6.1 146-150 BRIDPORT STREET ALBERT PARK
(PDPL/00817/2022)

1. PURPOSE

- 1.1 To determine Council's position on the proposed amended plans ahead of the Major Case Appeal hearing P357/2023 before the Victorian Civil and Administrative Tribunal (VCAT) listed to be heard over seven days on 8, 9, 10, 13, 14, 15 and 16 November 2023.

Image 2. Proposed amended plans from Bridport Street

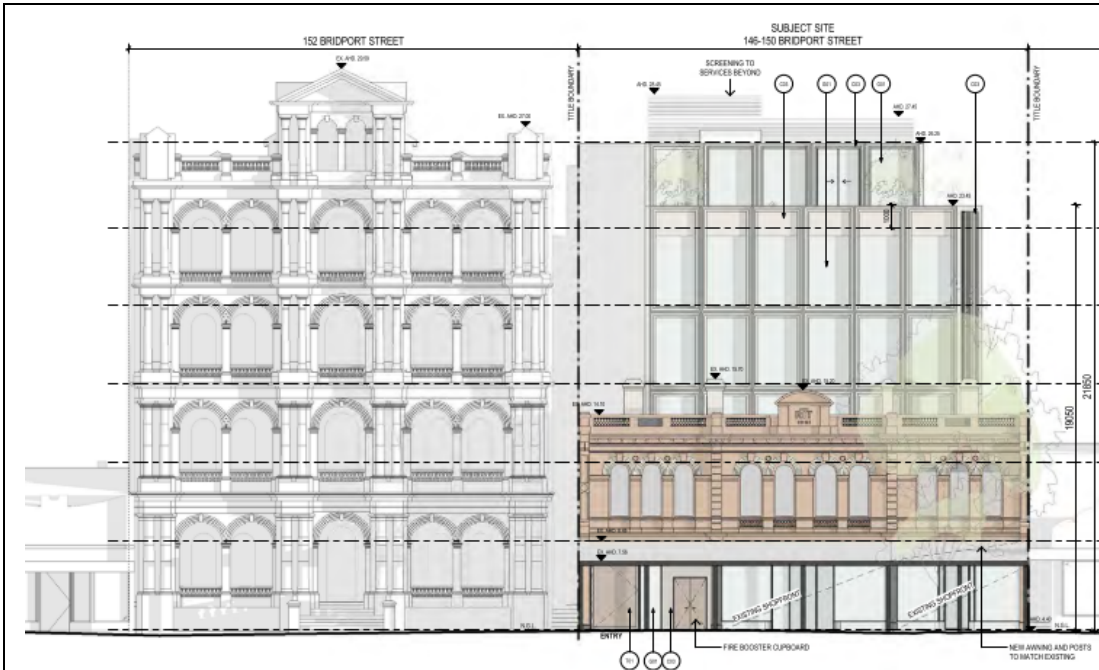
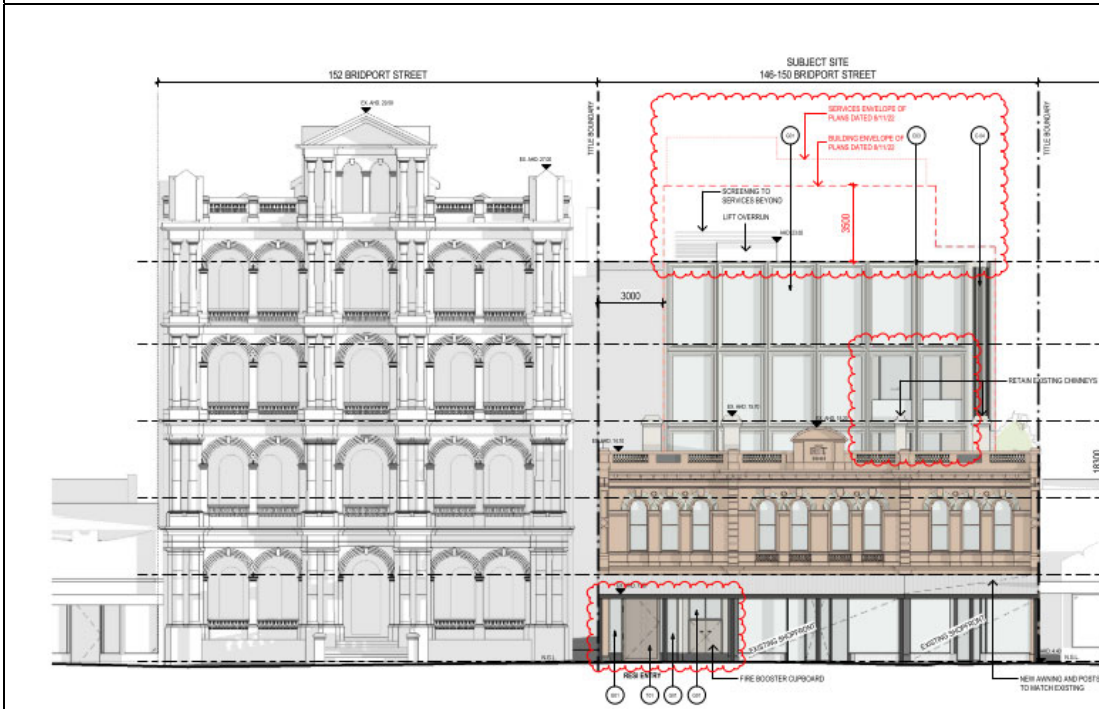
Specifically, the proposed design response in matching the height to the Biltmore (See Image 1 and 2) was considered to adversely impact on landmark status of the Biltmore building and the low-scale heritage character of the centre. This position was reflected in the officer's assessment against the decision guidelines within the delegate report.

The changes detailed in the proposed amended plans have addressed the height, massing and bulk of the building, refining the design detail and by providing greater setbacks.

Image 8. Heritage sightline diagram. Source: TP.3000 Proposed Amended plans, Cera Stribley.

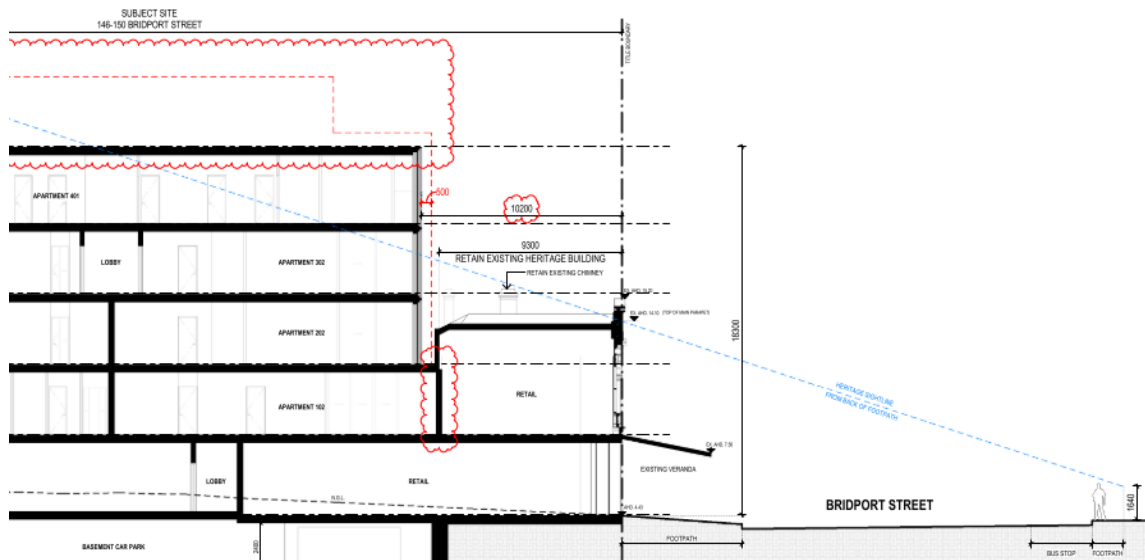
The degree of visibility has now been further reduced with minor incursions into the sightline diagram beyond the 'concealment' zone as demonstrated by Image 8 below.

It is now considered that the proposed amended plans have satisfactorily responded to the applicable heritage policy and resolved the concerns that form the basis of ground 2.

Image 9. Screenshot of existing 2 storey wall on boundary conditions. Source: Plan of Reestablishment and Detail Survey by JRL Land surveyors

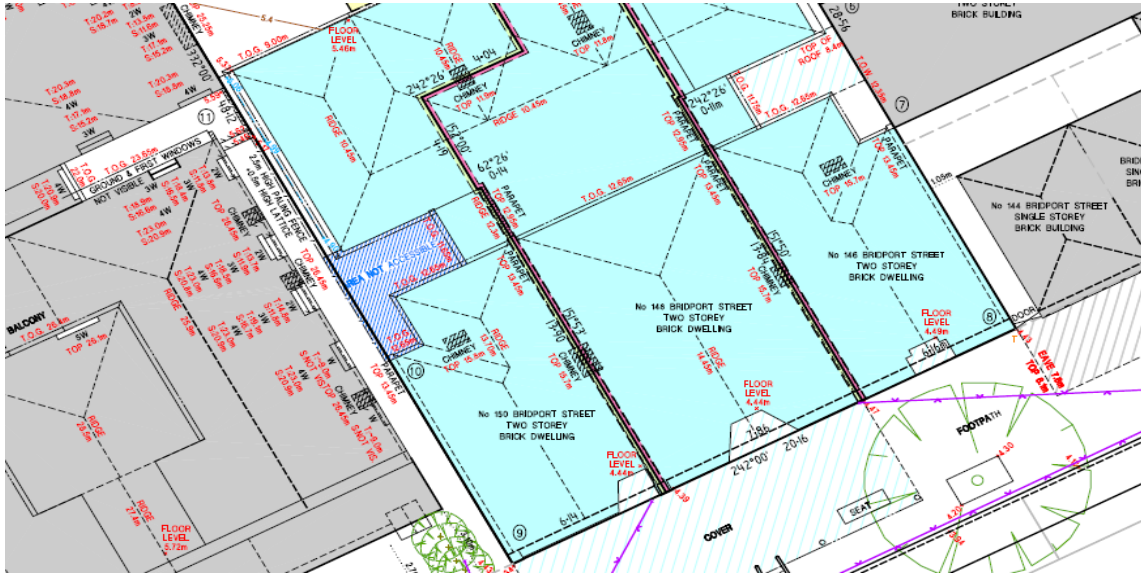
For the first 9.3 metres of the subject site's heritage building, the side setbacks are built on the boundary at ground and first floor. This area is not in contention as it is not proposed to change. It is an existing condition best understood when viewing the Plan of Reestablishment and Detail Survey by JRL Land surveyors (**Attachment 6**). A screen shot is provided below at Image 9.

Image 15. Screenshot of first floor wall on boundary in the proposed amended plans. Source: Source: TP.1101 Advertised plans, Cera Stribley.

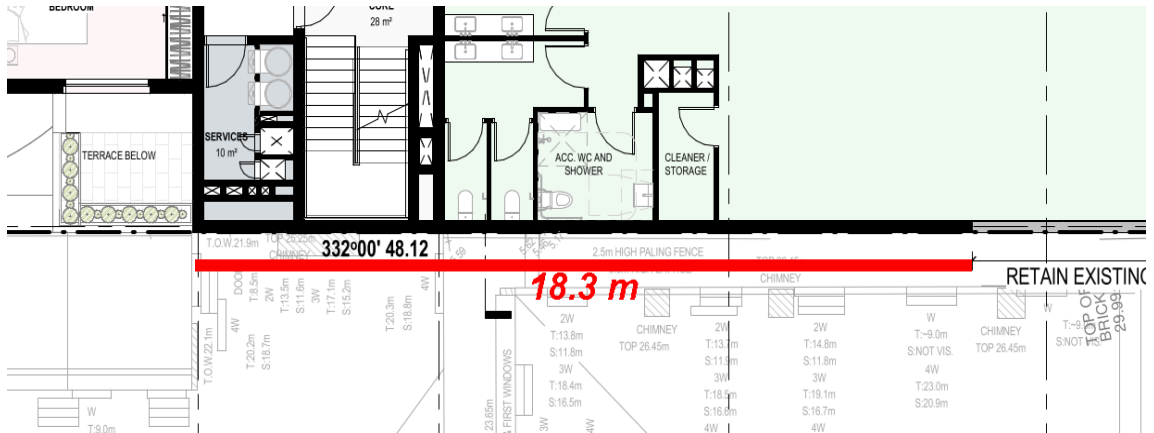
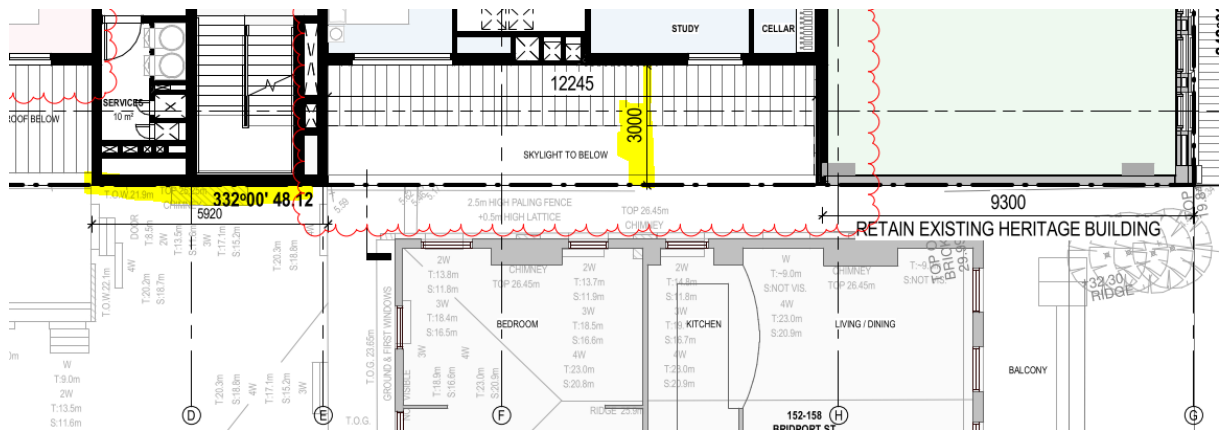
The built form that was not considered acceptable was the ~18 metre first floor wall on boundary that extended past the retained heritage wall. This wall is opposite two habitable room windows - one bedroom (studio) and one kitchen. The living room does not contain windows to this boundary. This is evident in Image 10 and 11 below that highlights the first floor east facing windows of the Biltmore.

The proposed amended plans now provide a new 3 metre setback at the first floor, where it extends beyond the retained heritage building. The only remaining wall on boundary to all levels is the wall related to the core/lift as shown in Image 15 below.
